## TVA-63-183A+ PCN Report

**AN-60-080**

As a result of the introduction of RoHS compliant version and assembly option at an alternate qualified Mini-Circuits facility, the replacement part has been judged by the Mini-Circuits Engineering team as a suitable replacement for the existing TVA-63-183.

## COMPARISON PERFORMANCE CURVES<sup>a</sup>:

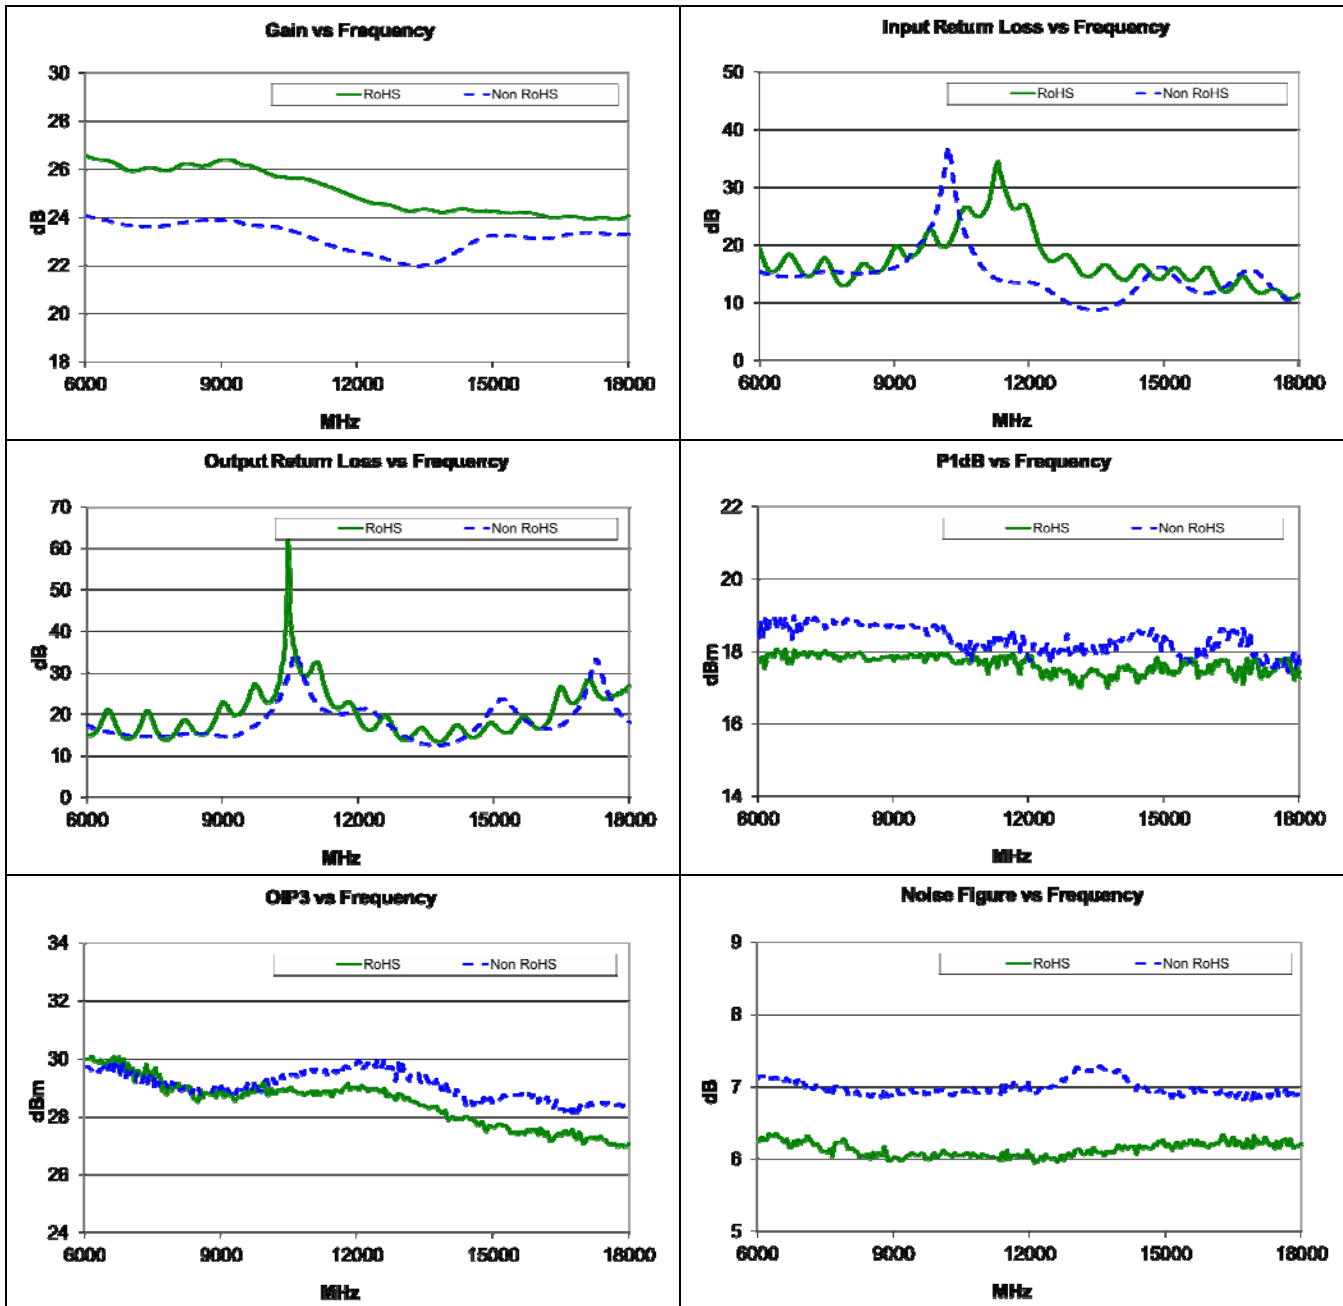
### 3) TYPICAL PERFORMANCE COMPARISON<sub>a</sub>: T<sub>AMB</sub>=25°C

| Parameter          | Freq (MHz) | Non RoHS (TVA-63-183) |         | RoHS (TVA-63-183A+) |         |
| Gain (dB)          | 6000-18000 | 21.98                 | 24.06   | 23.51               | 26.57   |
| Gain Flatness (dB) | 6000-18000 | -----                 | +/-1.04 | -----               | +/-1.49 |
| P1dB (dBm)         | 6000-18000 | 17.48                 | -----   | 17.06               | -----   |
| OIP3 (dBm)         | 6000-18000 | 28.26                 | -----   | 26.97               | -----   |
| Noise Figure (dB)  | 6000-18000 | -----                 | 7.28    | -----               | 6.4     |
